Architect's Supplemental Instructions

Architect's ASI No: 030

Project:
Webster University
Interdisciplinary Science
Building

Description:

T0001

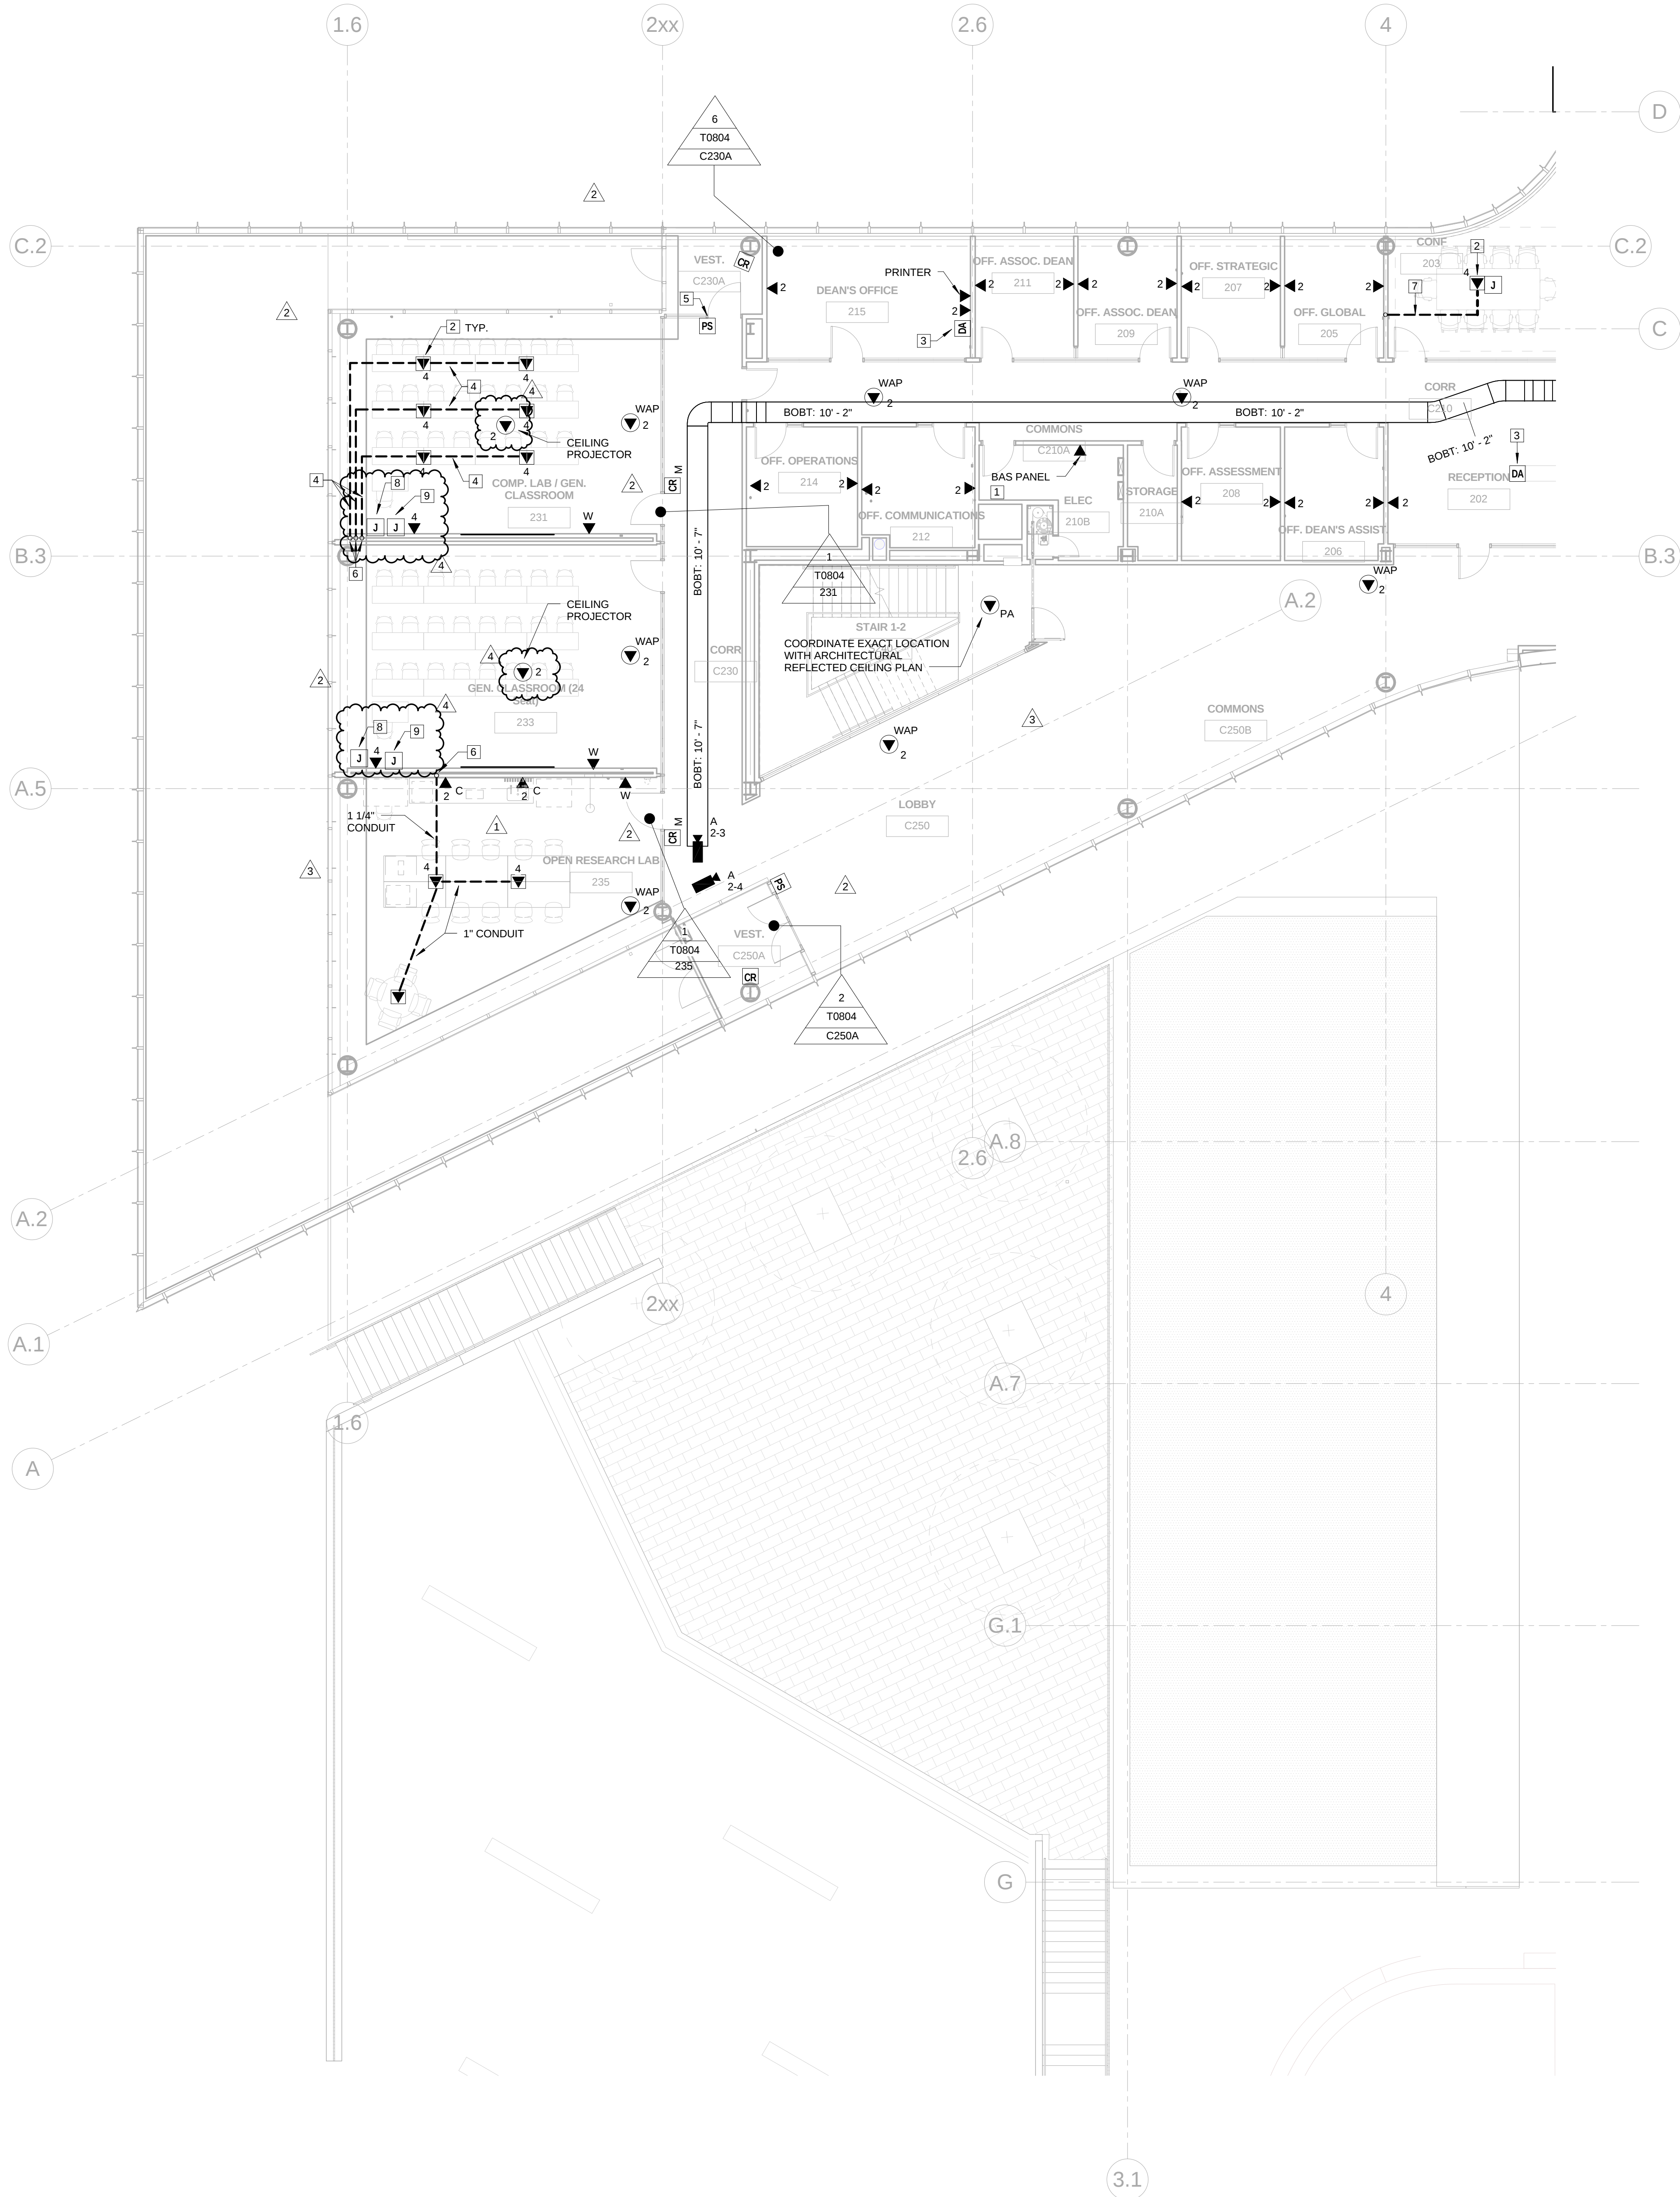
1. T0001 – SYMBOLS AND ABBREVIATIONS
 - A. Revised symbol descriptions.
2. T0101.B – LEVEL 01 FLOOR PLAN – AREA B
 - A. Revised AV infrastructure in several locations.

T0102.B

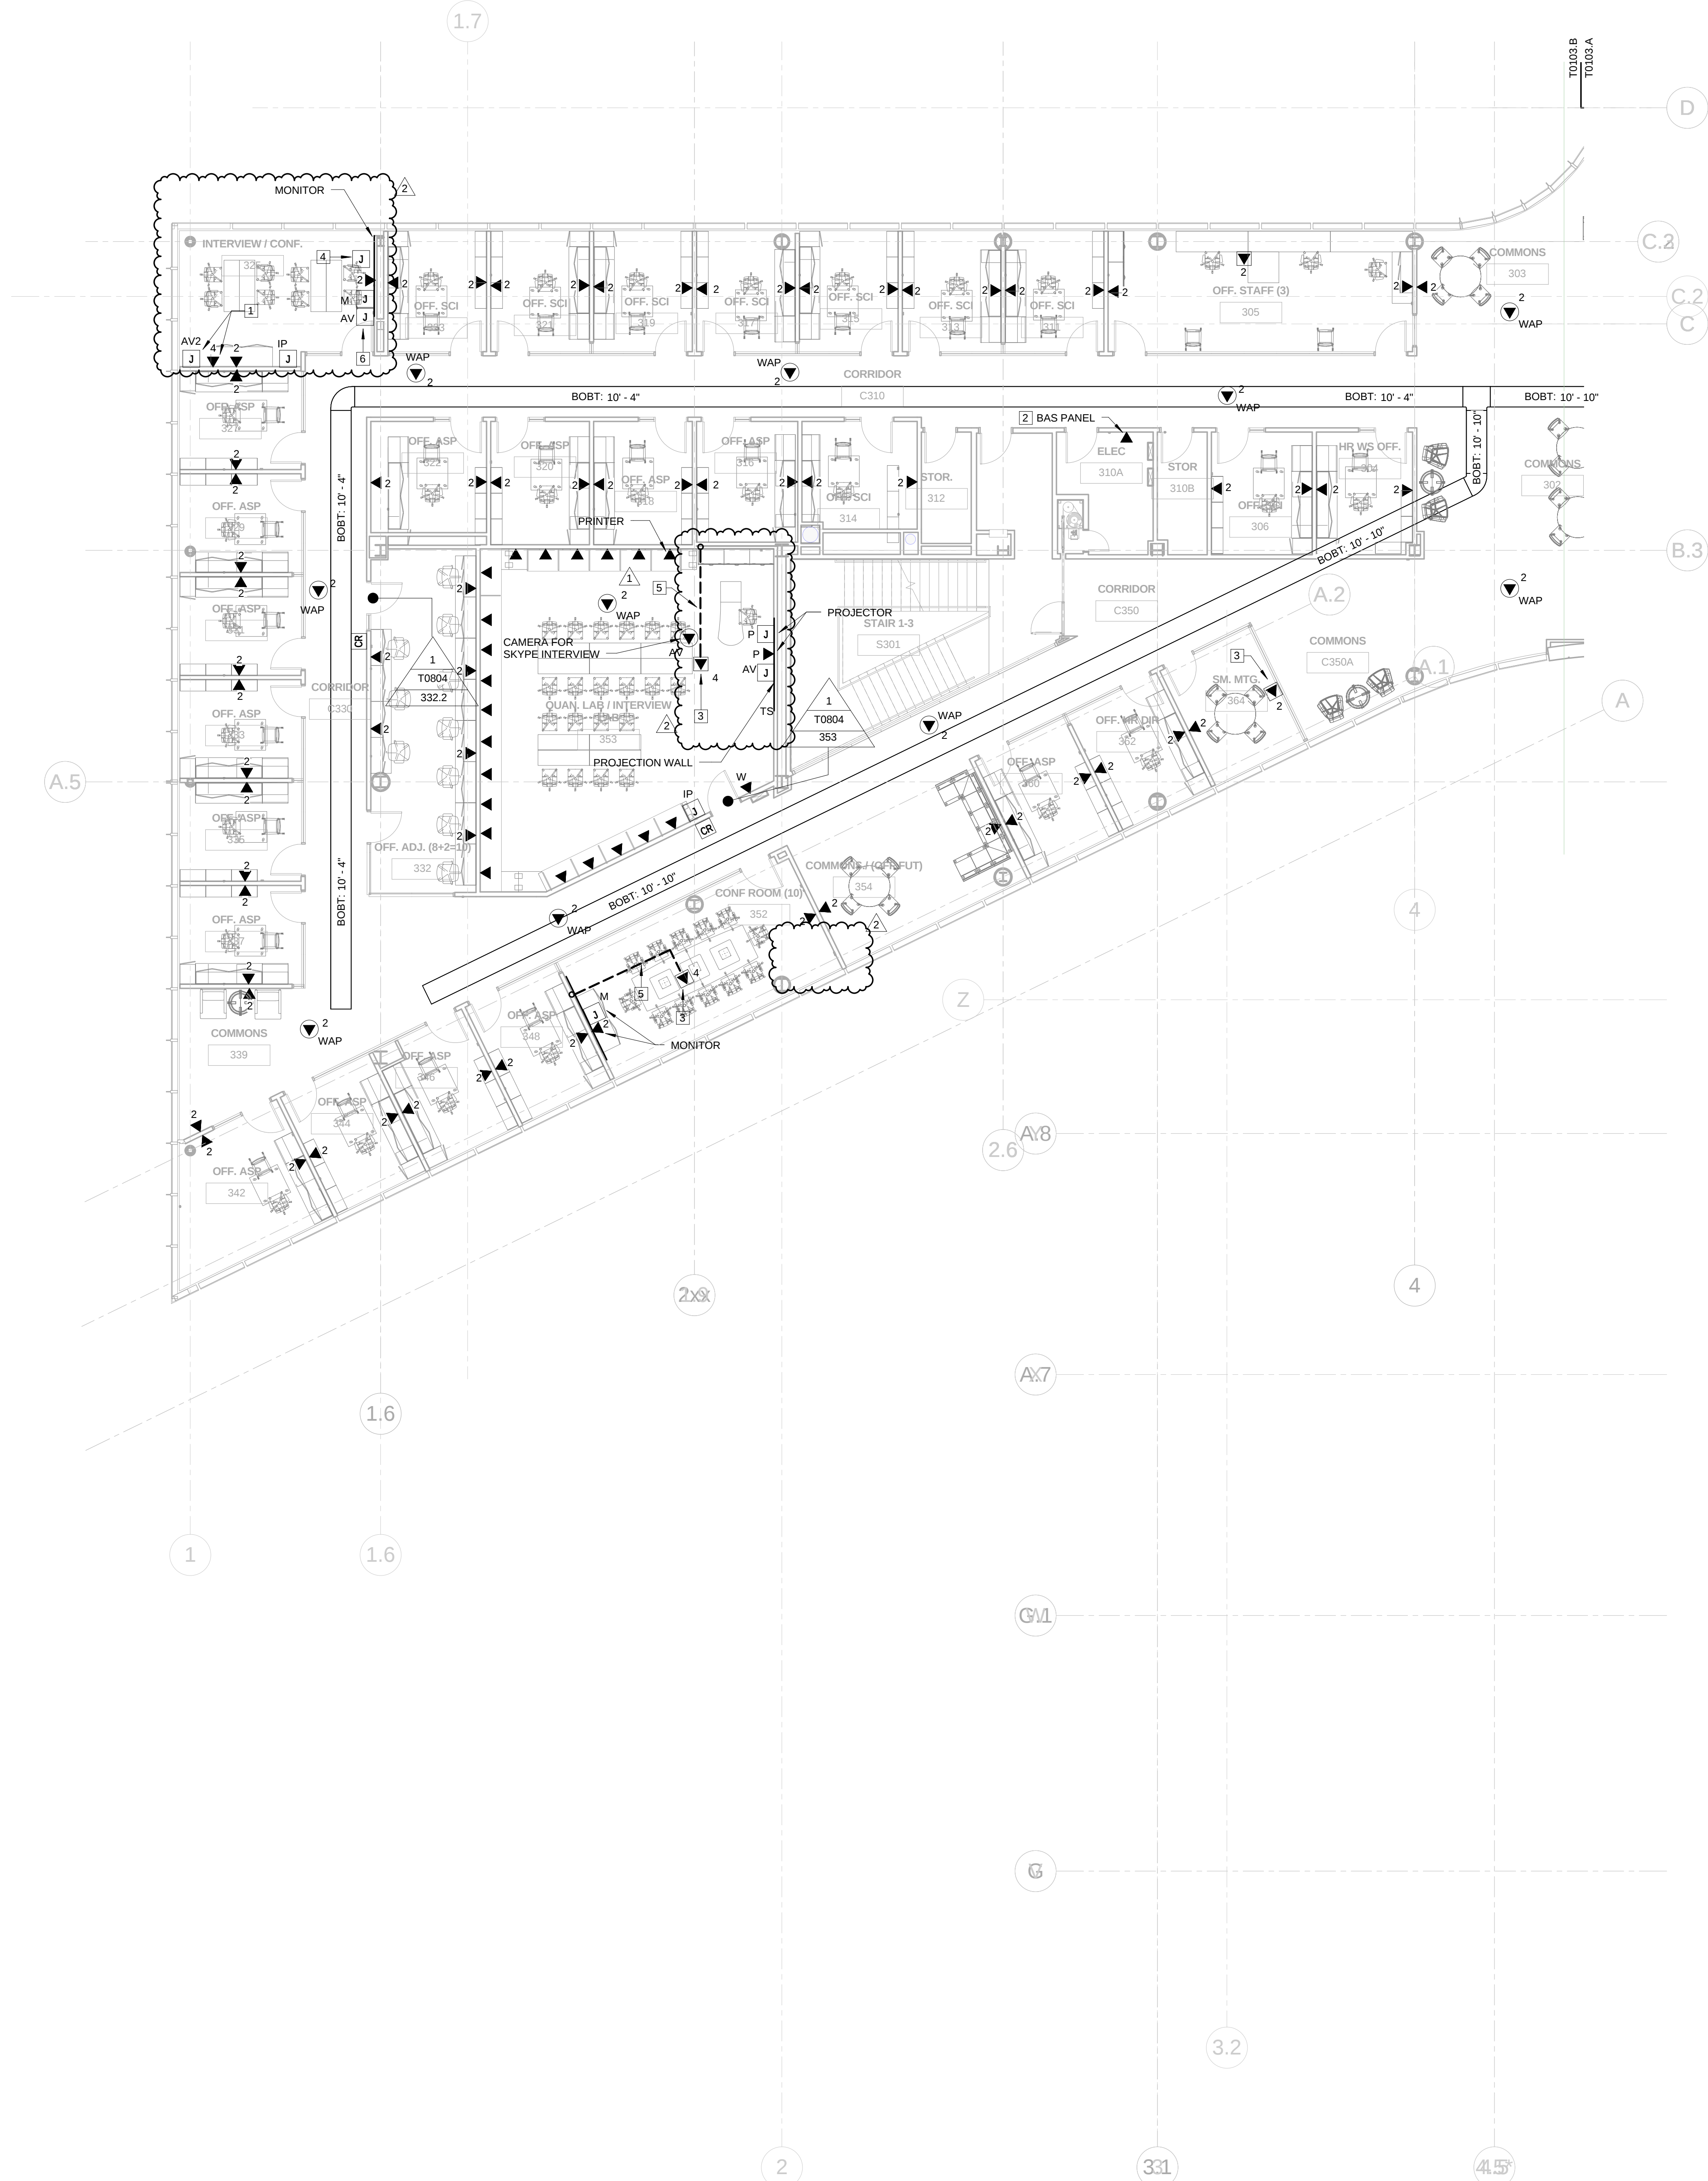
3. T0102.B – LEVEL 02 FLOOR PLAN – AREA B
 - A. Revised AV infrastructure in Comp. Lab/Gen. Classroom 231 and Gen. Classroom 233
4. T0103.B – LEVEL 03 FLOOR PLAN – AREA B

E0101.B

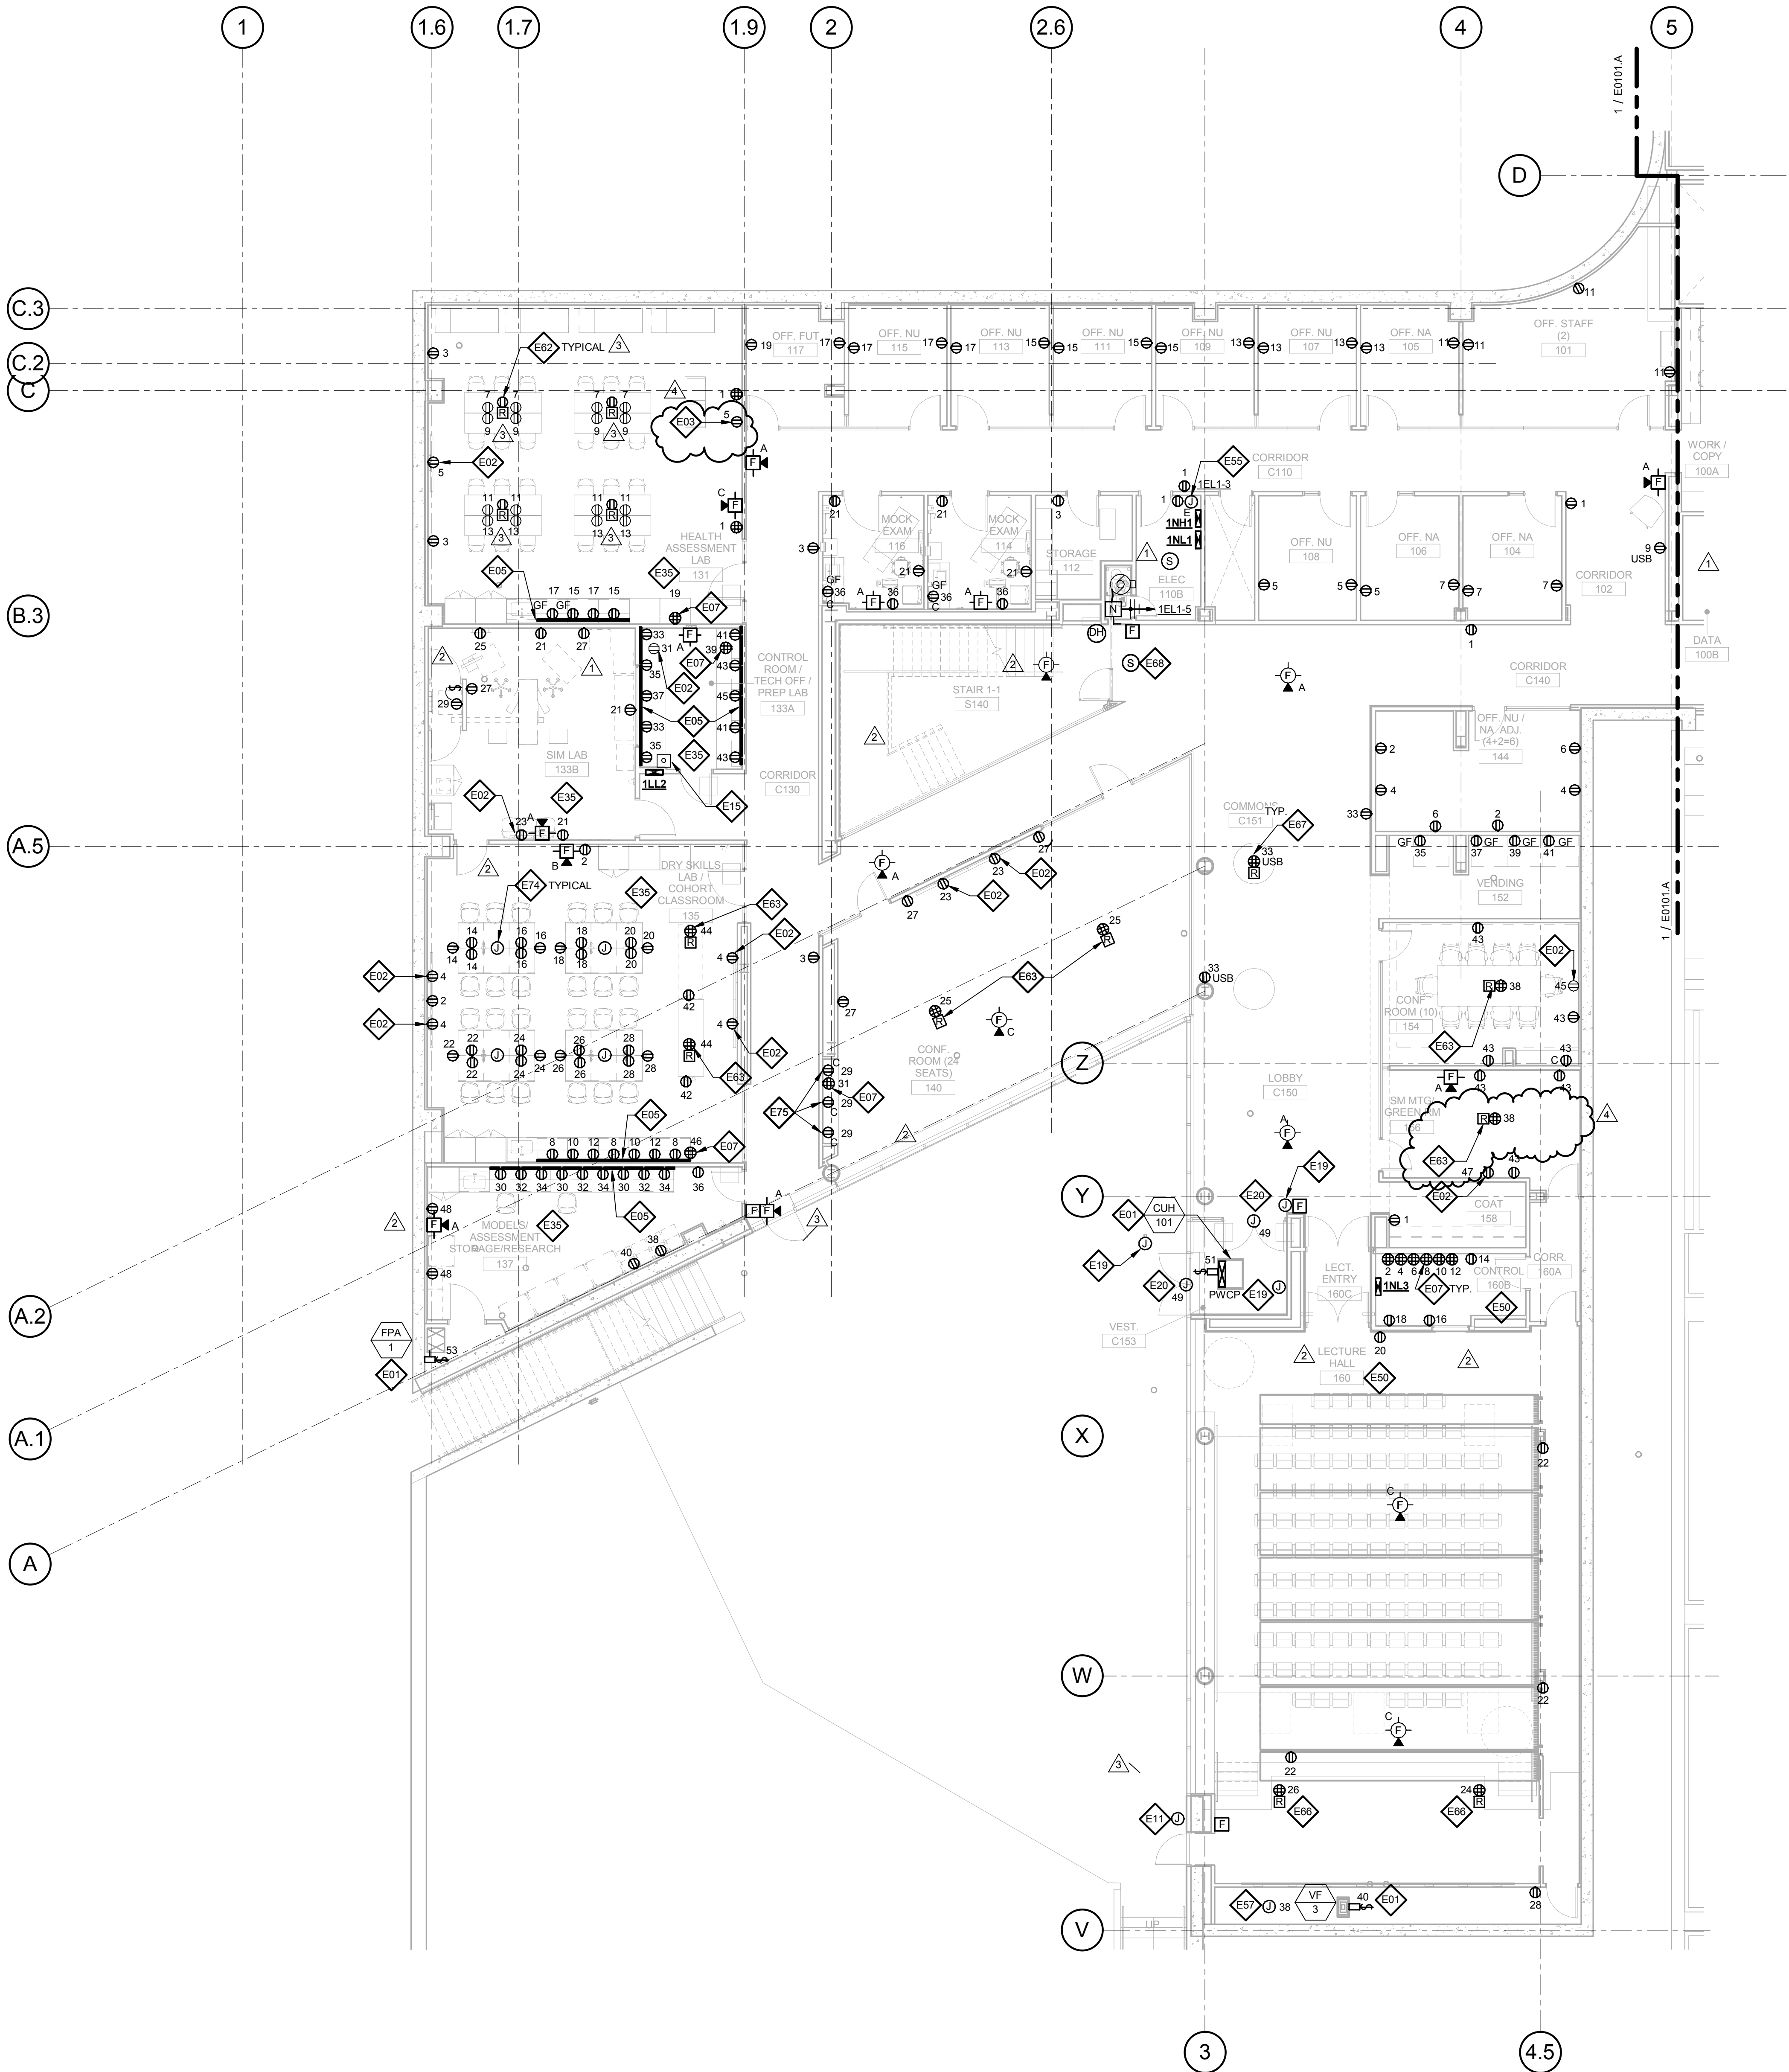
- B. Removed AV infrastructure in Small Meeting room 441.
6. E0101.B LEVEL 01 AREA B FLOOR PLAN – ELECTRICAL & AUXILIARY
 - A. In Room 131, move receptacle for TV on west wall north to match AV location.

- B. In Room 156, add floor box and associated Keyed Note E63. Circuit as indicated.
7. E0103.B LEVEL 03 AREA B FLOOR PLAN – ELECTRICAL & AUXILIARY
 - A. In Room 325, move quadruplex receptacle on south wall east to match AV location.
